RE: ADDENDUM NO.1  
Bid No.: 5016/17-35-0306-5000-3500-UCP-GVG  
Proposal: City of Hidalgo – 2016 Parks, Recreational  
Facility Improvements (Valle Alto Park)

# ADDENDUM NO. 1

Proposal: **"City of Hidalgo Parks/Recreational Facility Improvements**

WALKING TRAIL CROSS SECTION

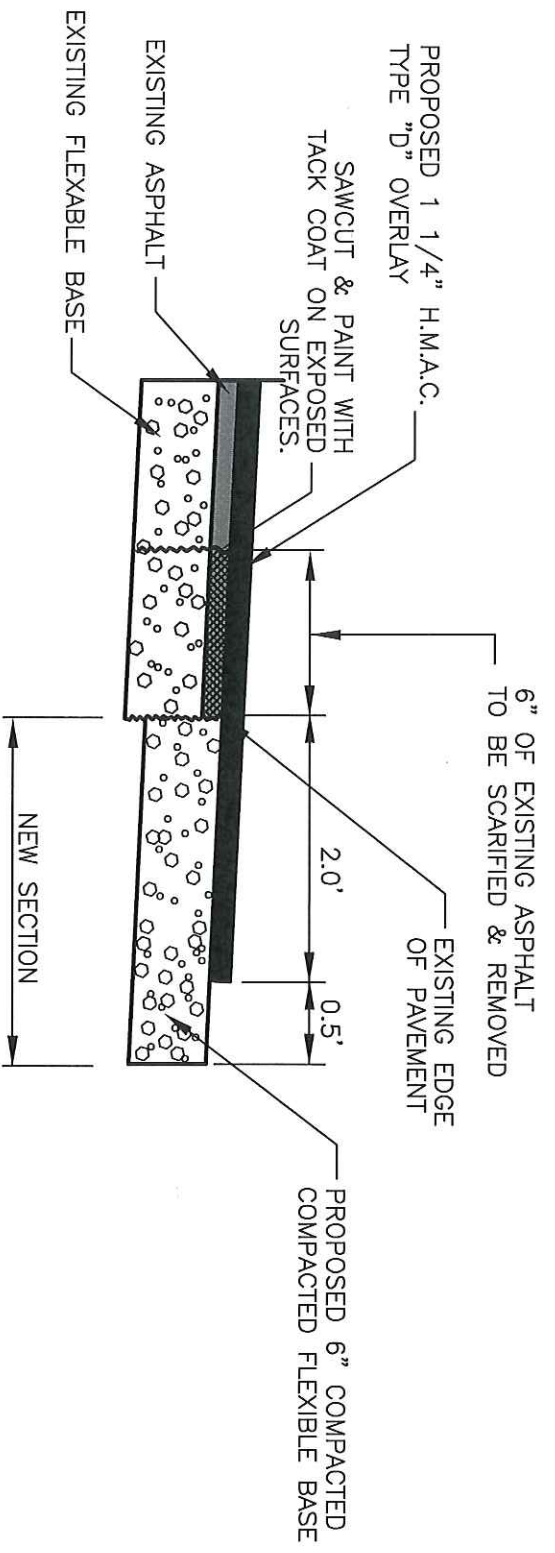
1. The attached Wage Rates (Wage Decision No. TX180305 09/14/18 TX305) shall replace the Wage Rates (Wage Decision No. TX180305 01/05/18 TX305) found in the contract documents. The Contractor shall utilize these updated Wage Rates in the preparation of the Bid.
2. Refer to Appendix A, Section 07412 pages 7 & 8 for information regarding roofing panels, gutters and downspouts.
3. Attached is a cross section of the walking trail improvements.
4. Specification Section 08710 (Finish Hardware).
